Subject: Offsite Dose Calculation Manual  
Revision 27

The General Office Radiation Protection Staff is transmitting to you this date, Revision 27 of the Offsite Dose Calculation Manual. As this revision only affects Oconee Nuclear Station, the approval of other station managers is not required. Please update your copy No. 30, and discard the affected pages.

JUSTIFICATIONS FOR REVISION 27

LIQUID RADWASTE SYSTEM  
OCONEE NUCLEAR STATION  
FIGURE A1.0-1

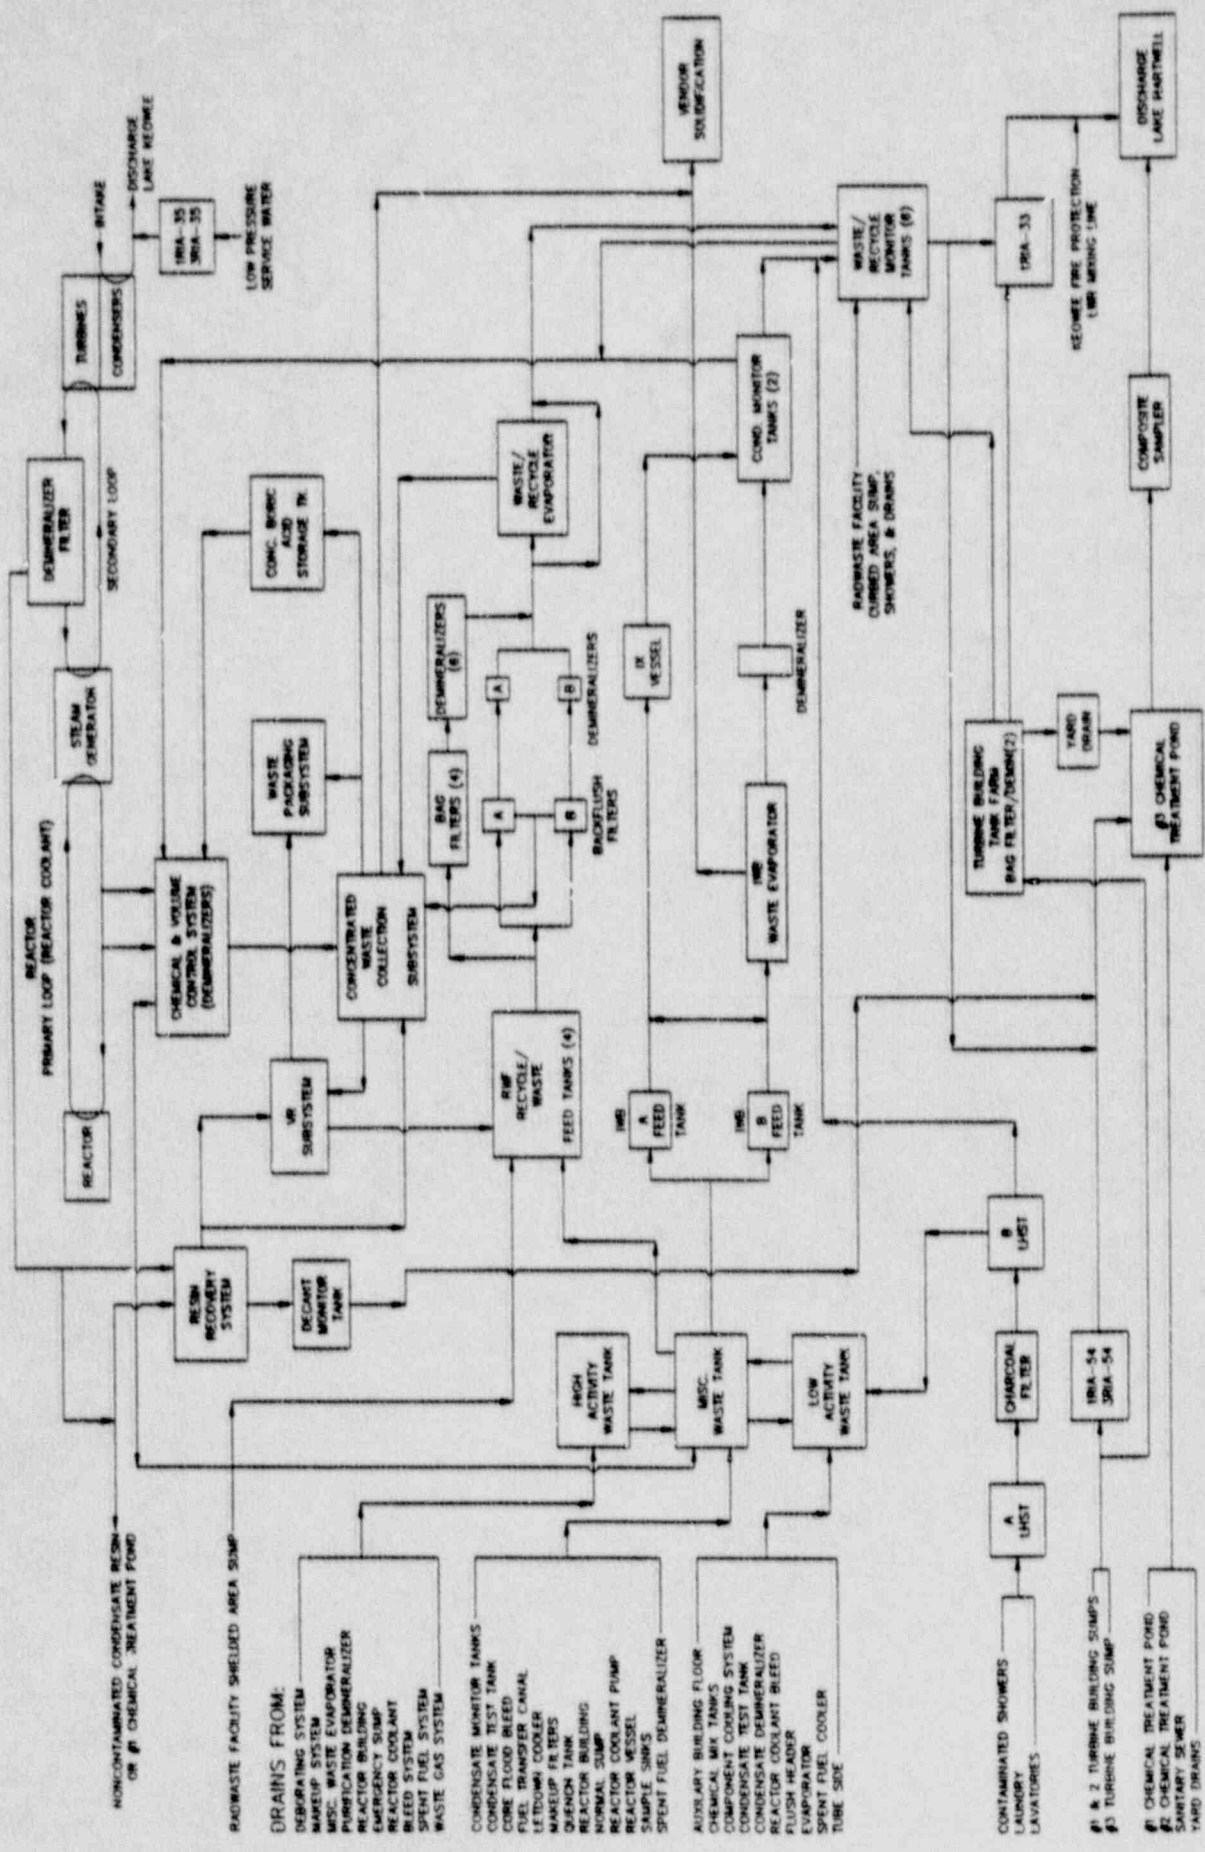
Figure A1.0-1	Replaced figure with CAD drawing. Updated to reflect actual station operation and/or to provide additional information.
Figure A1.0-2 (4 pages)	Replaced figure with CAD drawing. Updated to reflect actual station operation and/or to provide additional information.
Page A-3	Changed wording to reflect actual station operation. Changed the minimum dilution flow rate available from 17054 gpm to 3.41E+04 gpm in order to take credit for the additional dilution flow provided by the Keowee Hydro Fire Protection-LWR Mixing Line.
Page A-5	Corrected typo errors in Table Numbers.
Page A-6	Provided additional information for clarity purposes and changed mileage information for consistency purposes.
Page A-7	Corrected typo errors in Table Numbers.
Page A-8	Corrected "dispersion/dispersion" to "dispersion/deposition". Provided additional information for clarity purposes and changed mileage information for consistency purposes.
